**P802.3dj Physical layer jitter (Clause 176/179) proposal to advance/close current comments against present JRMS and J4u03 methodologies Presented to IEEE P802.3dj Electrical Task Force January 2025.
Version 1.0: January 20, 2025**

**Contributors: David Gines, Ryan Chodora, Mike Beyers.
Based on draft release of IEEE P802.3dj™/D1.3 Comments**

Abstract: Comments recorded against P802.3dj D1.3 (306, 219, 220, 221) are calling out for improved handling of jitter. Based on the straw-polling of gines_3dj_optx_01a_250109.pdf conducted on 01/09/2025 this contribution drives to addressing these comments

Composite
The JNU values for rising (red) and falling (blue) are shown for reference.

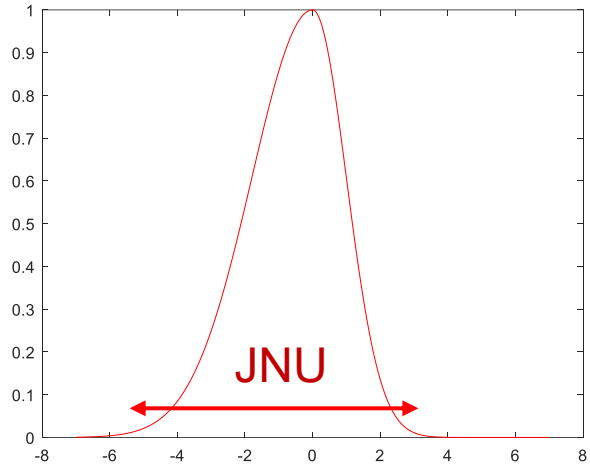
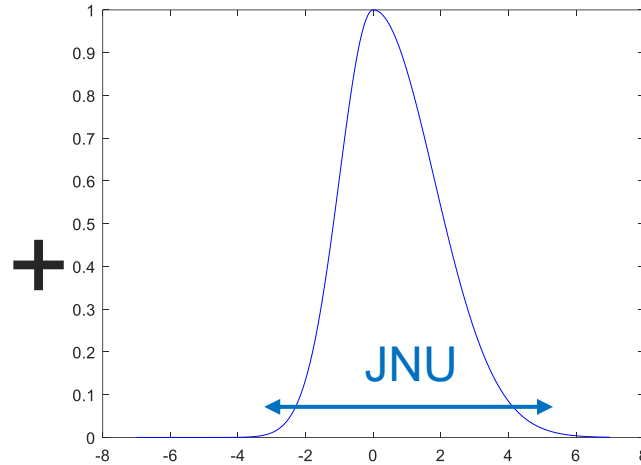
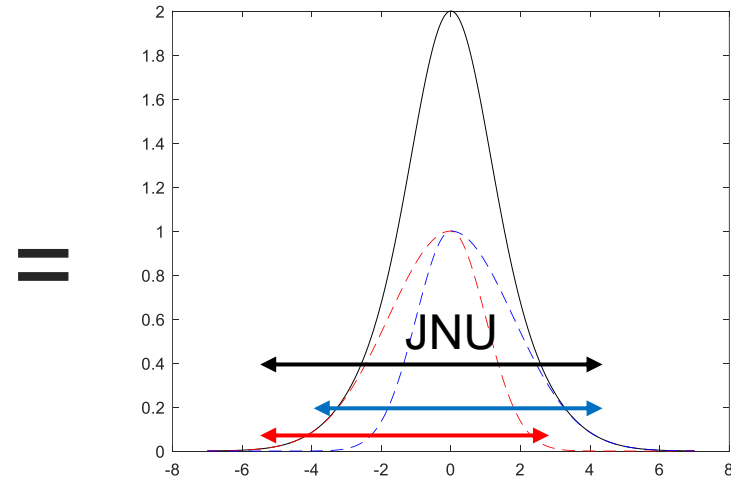
Jitter measurements refer to 120D.3.1.8.1 for the probability distribution calculation method... The method of combining the distributions should be improved to mitigate additive noise and slope dependence.

The composite histogram can have a higher JNU value than the sum of individual JNU values when histograms are not symmetric. This example shows a long tail to the left for rising, and a long tail to the right for falling edges.

120D.3.1.8.1 J4u and J_{RMS} jitter

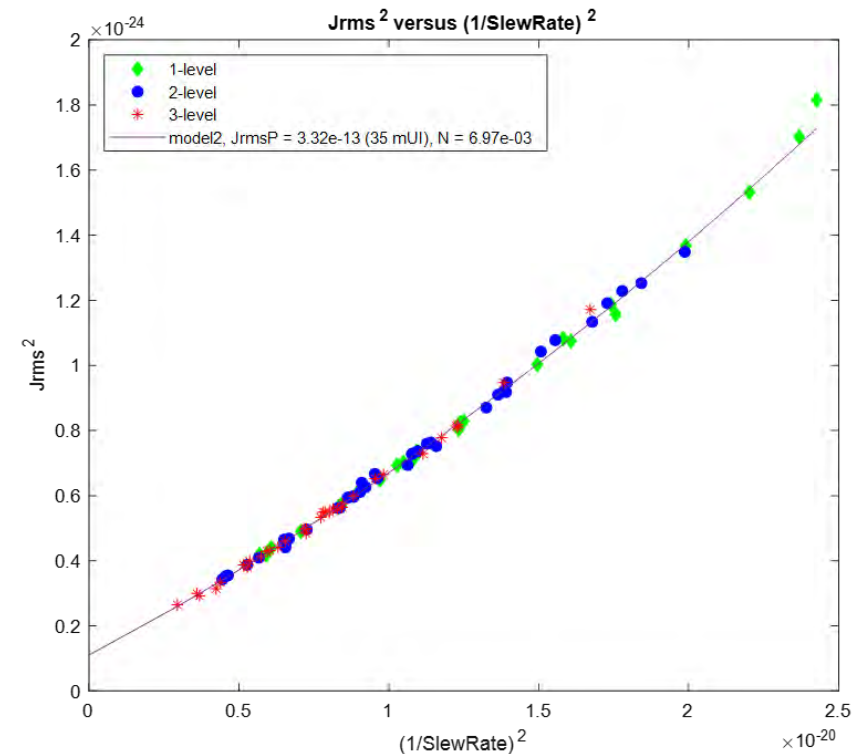
Jitter measurements refer to 120D.3.1.8.1 for the probability distribution calculation method... The method of combining the distributions should be improved to mitigate additive noise and slope dependence.

- As illustrated in [calvin_3dj_01b_2407](#) Pg 7, the process of “combining the sets” results a composite result that is substantially greater than the sum of it’s parts.
- Rising edge J_{nu} histograms have a “left” bias, and corresponding falling edge histograms have a “right” bias. “Combining” or adding these two histograms into a composite value has always been problematic.
- It is recommended that within a given transition level class (e.g. 3 level transitions) that the composite value be associated with the maximum of the individual distributions, not their sum.

Q-Scale and Jitter components (Rj only)

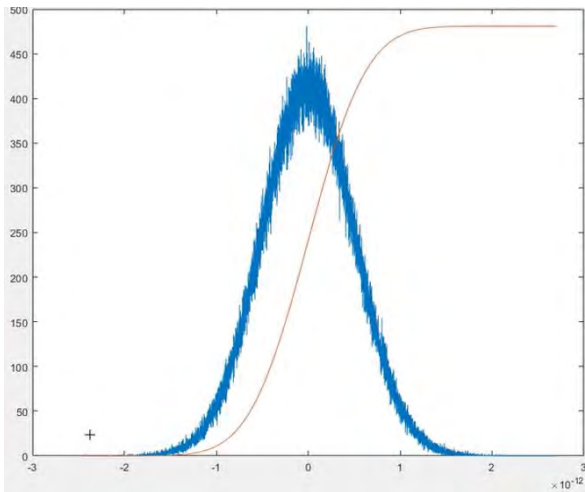
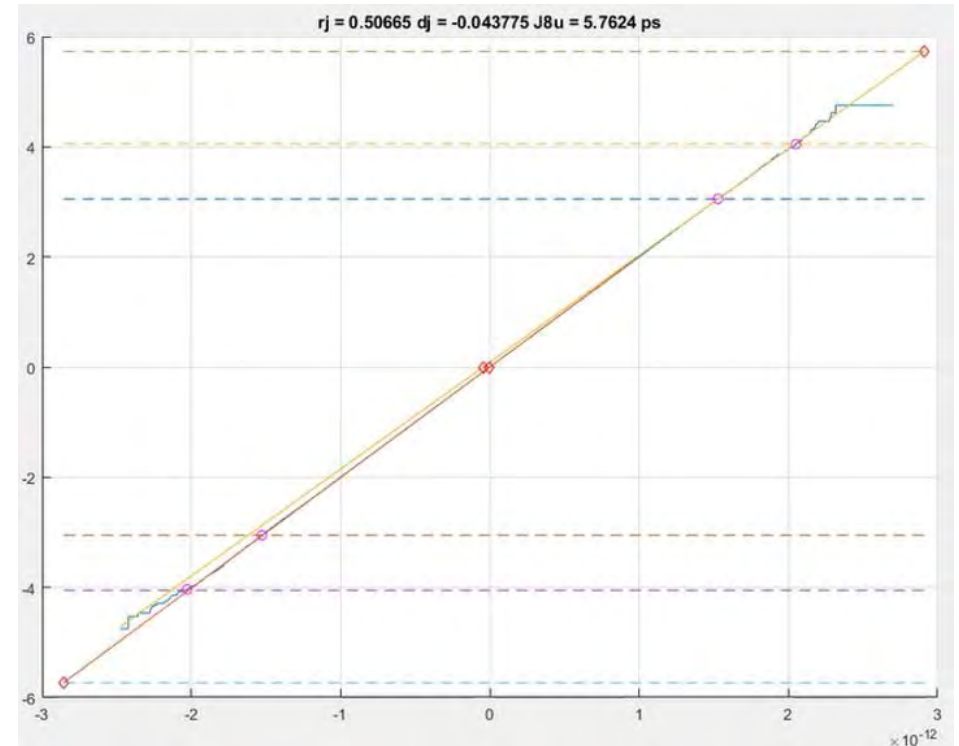
J3u and JRMS measurements at TP2 are highly affected by the effects of slew rate and noise and do not reflect actual uncorrelated jitter.. A different methodology that will better quantify phase-only uncorrelated jitter has to be explored

The Jnu and JRMS operations need to be separated for this comment. A methodology that is highly resilient to channel loss has been described in [gines 3dj optx 01a 250109](#) and introduces the concept of JHRMS which is largely what the original spec writers intended rather than what was described in 120D.3.1.8.1.

The Jnu operations need to be modeled with one proposal described in [gines 3dj optx 01a 250109 \(Pg 12\)](#) the only thing needing extraction here is DJHdd which should correspond to Add.

RJ Compensation 12-edge Synthetic 5mv RN,40mUI DJ, 31dB Channel 0RJ

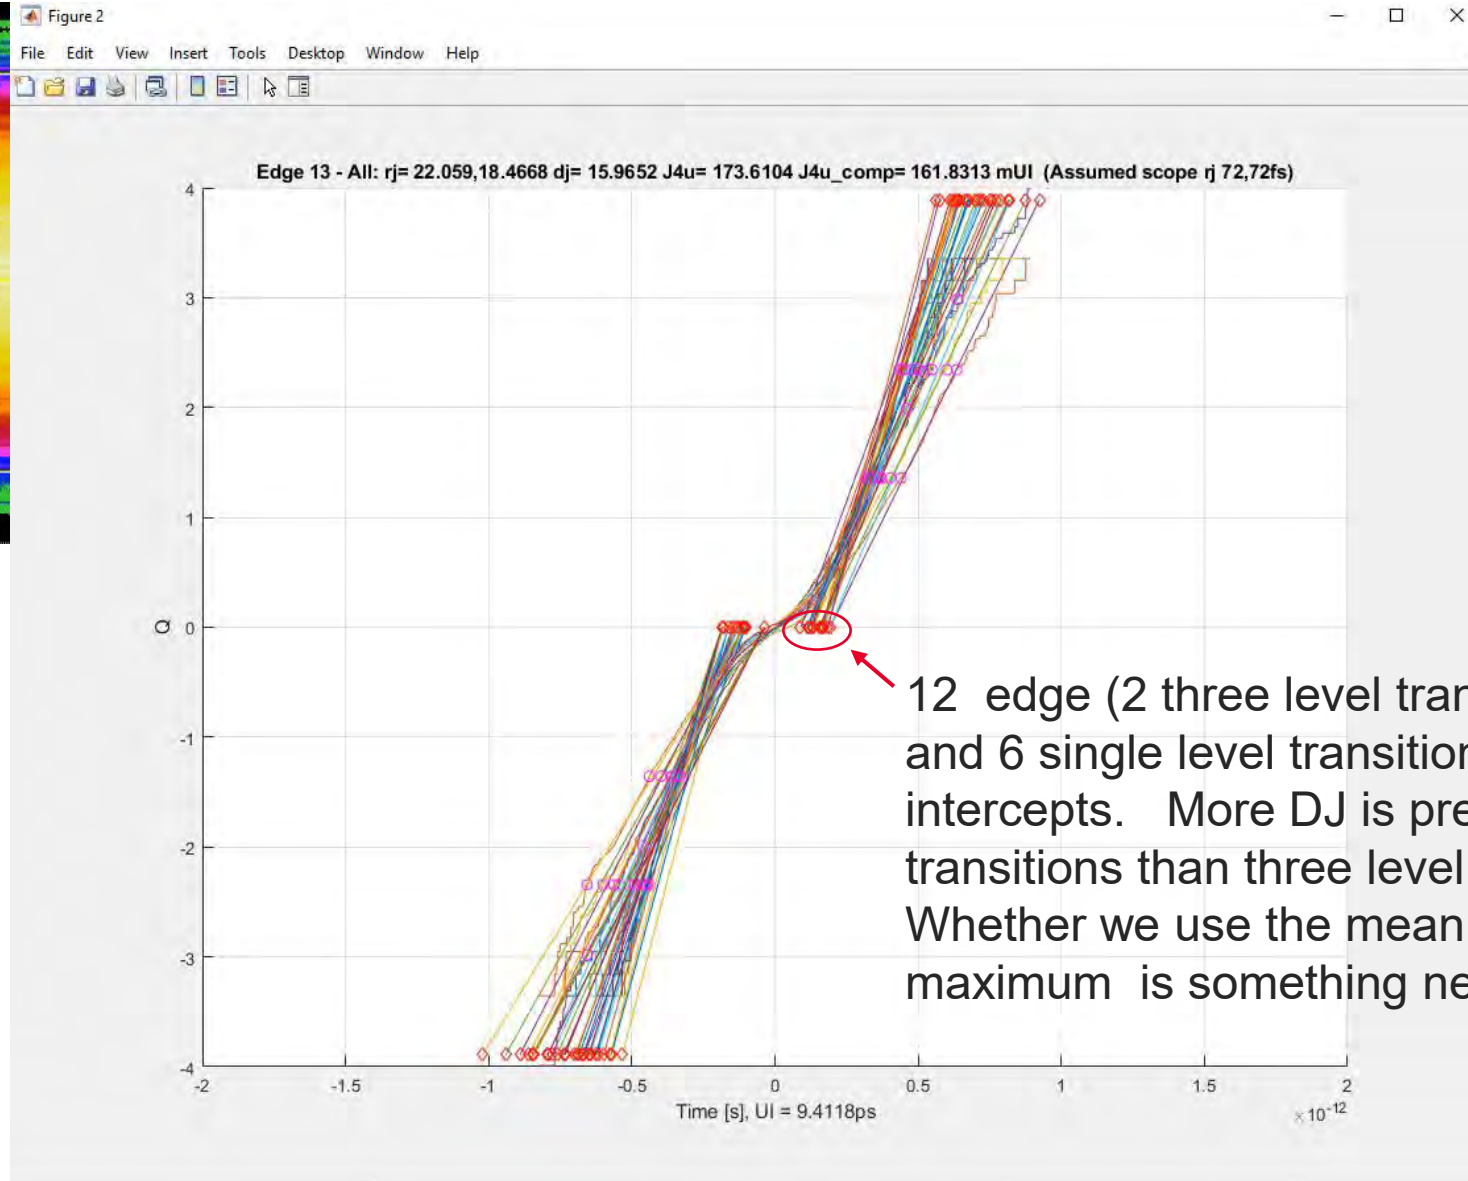
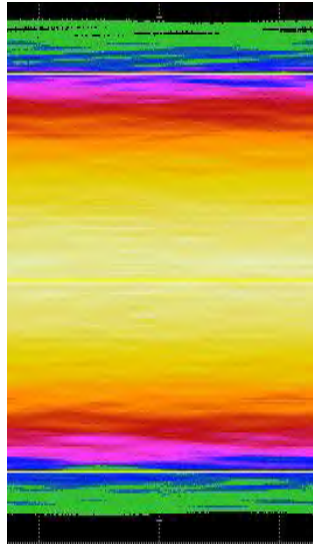
- The JHRMS relies on a "y-intercept" method of determining the random jitter.
- This DJHdd similarly operates on a "x-intercept" of the Q-Scale transformed edge distributions.

12 edge (2 three level transitions, 4 two level transitions and 6 single level transitions) provide a distribution of x-intercepts. More DJ is present in single level transitions than three level transitions. Whether we use the mean of these DJ intercepts, or maximum is something needing research.
